# Access Compliance Report

## Public Rights-of-Way

### (Curb Ramps)

Intersection ID: N/A	Main Street: E_4TH_ST	Cross Street: JOHN_BELK_RA	Location: W
ADA ID: 6E06DBDD9F7D	Ramp Type: Perp	Initial Pass/Fail: Fail	Overall Compliance: No
		Severity Score: 12.5

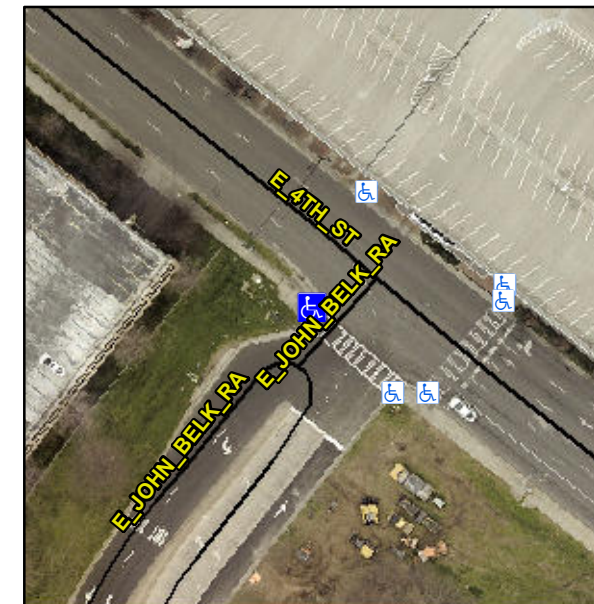
**R304.2.2**

Compliance	Description	Data	Compliance	Description	Data
N/A	Ramp Length (in)	50.0	No	Ramp Slope (%)	9.7
Yes	Ramp Width (in)	48.0	Yes	Ramp XSlope (%)	0.6
N/A	Flare Type LT	N/A	N/A	Flare Type RT	N/A
N/A	Flare Slope LT (%)	N/A	N/A	Flare Slope RT (%)	N/A
N/A	Flare Traversable LT?	No	N/A	Flare Traversable RT?	No
N/A	Landing Length (in)	N/A	N/A	DWS Provided?	N/A
N/A	Landing Width (in)	N/A	N/A	DWS Contrast?	N/A
N/A	Landing Slope (%)	N/A	N/A	DWS Length (in)	N/A
N/A	Landing X Slope (%)	N/A	N/A	DWS Full Width?	N/A
N/A	Landing Curb? (Y/N)	N/A	N/A	DWS Offset (in)	N/A
N/A	Shared Landing?	N/A			
N/A	Gutter Ponding?	N/A	N/A	Gutter Slope (%)	N/A
N/A	Gutter Lip Ht (in)	N/A	N/A	Gutter X Slope (%)	N/A
N/A	Painted X Walk1?	Yes	N/A	Painted X Walk2?	N/A
	X Walk 1 Direction	To SE		X Walk 2 Direction	N/A
N/A	X Walk 1 Width (in)	109.0	N/A	X Walk 2 Width (in)	N/A
	X Walk 1 Slope (%)	5.9		X Walk 2 Slope (%)	N/A
	X Walk 1 X Slope (%)	1.7		X Walk 2 X Slope (%)	N/A

**Remove & Replace Entire Ramp.**
